**SUBJECT: RESPONSE TO FIRST ITERATION REVIEW OF CINGULAR WIRELESS FACILITY ZAP 05-016  
SYCAMORE CANYON**

## **NOISE IMPACT ANALYSIS**

**Nextel Communications  
Site Number: CA-8412  
Site Name: Sycamore Canyon  
1853 Honey Springs Road  
Jamul, California 91935**

**County of San Diego Limited Use Permit  
Case Number: P05-016**

Figure 8

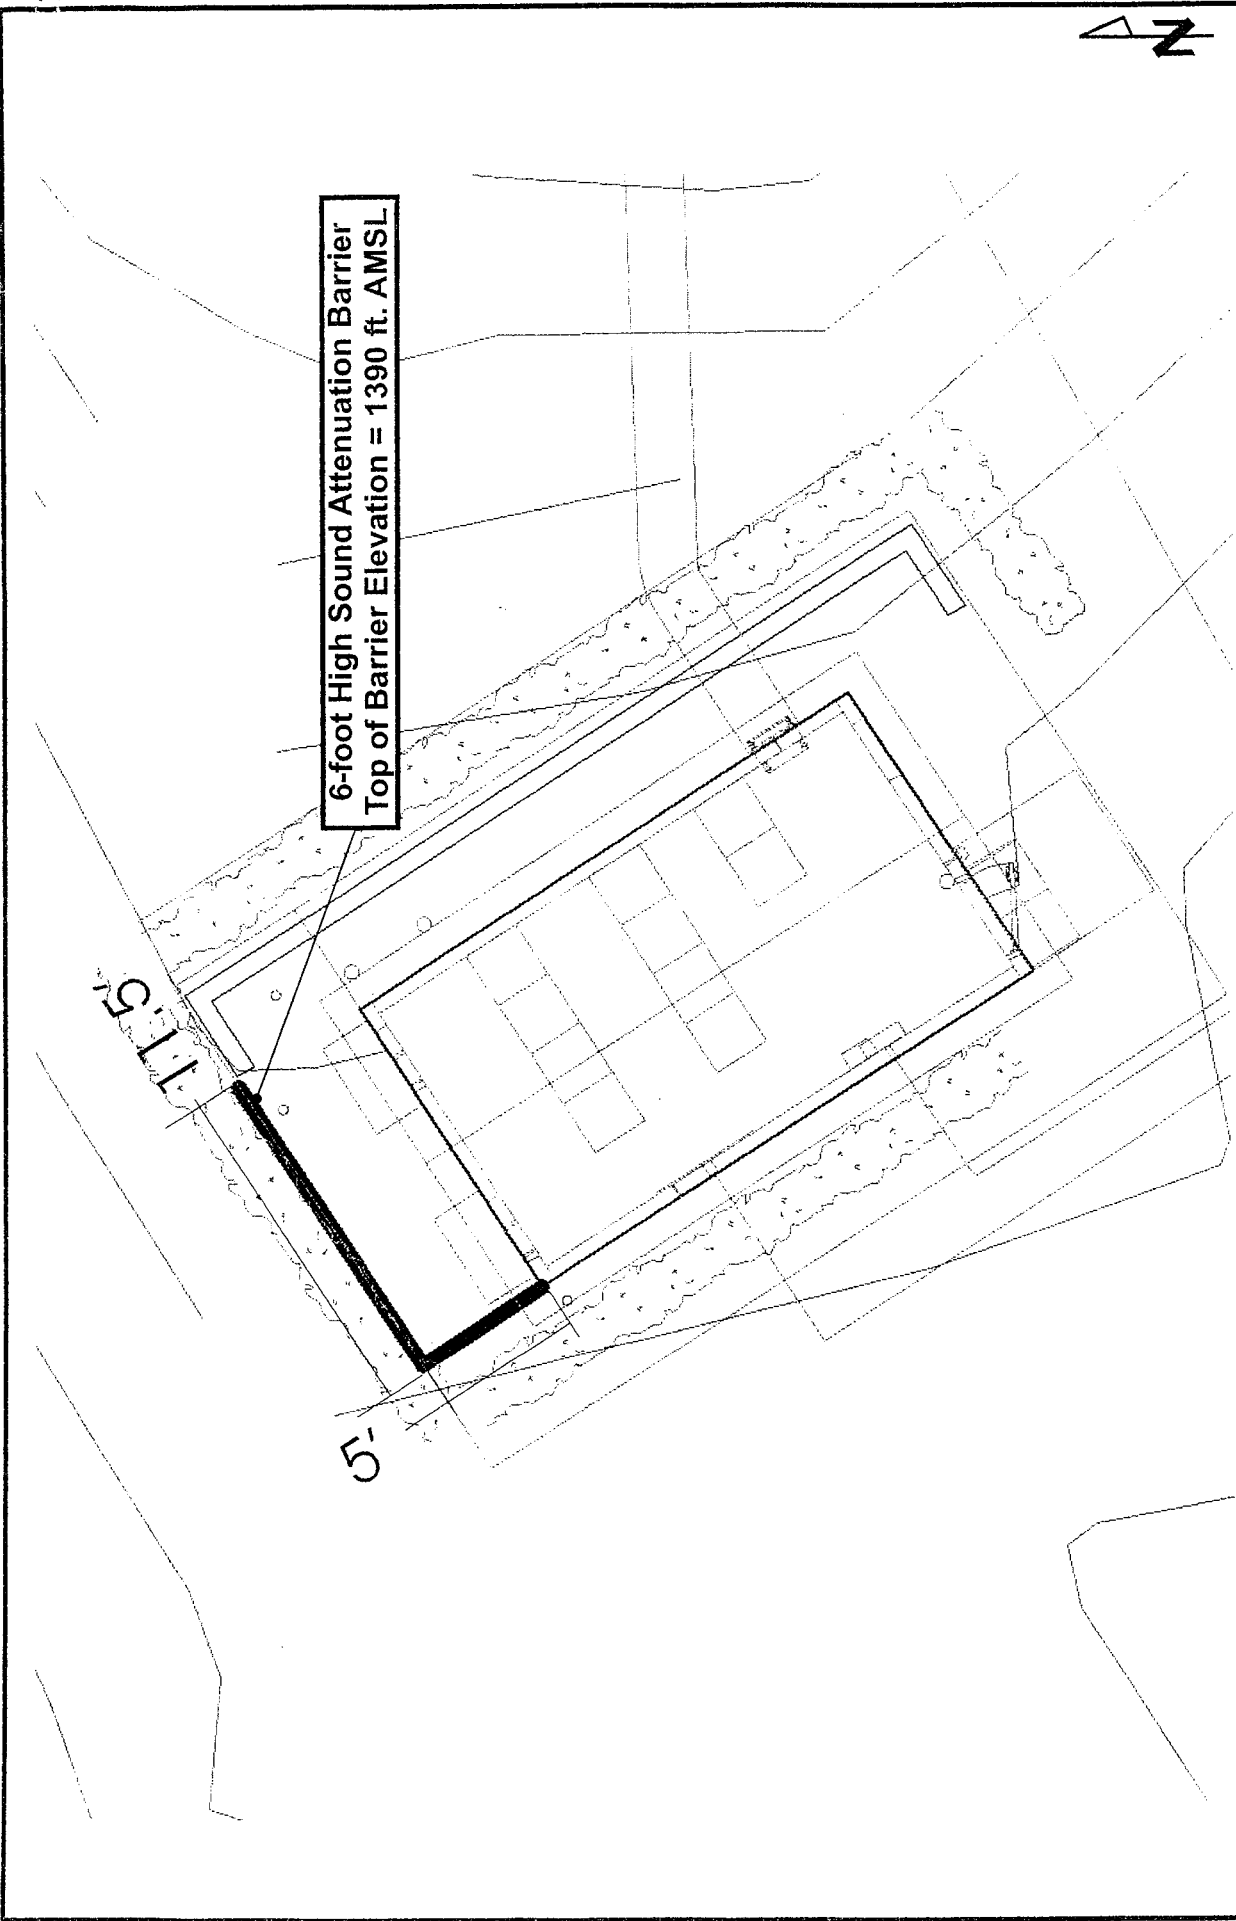
5. *Please provide a separate scaled exhibit or figure showing the location, length, and required top of barrier elevation for the proposed 6-foot tall sound attenuation barrier (mitigation measure) for this project. There appears to be a discrepancy between the "Enlarged Site Plan" in Appendix A and the one found in the recently submitted site plans (Sheet A-401). Please demonstrate the feasibility of the mitigation and the future access to this equipment.*

Response: An additional exhibit of the sound attenuation detail has been provided as Figure 8.
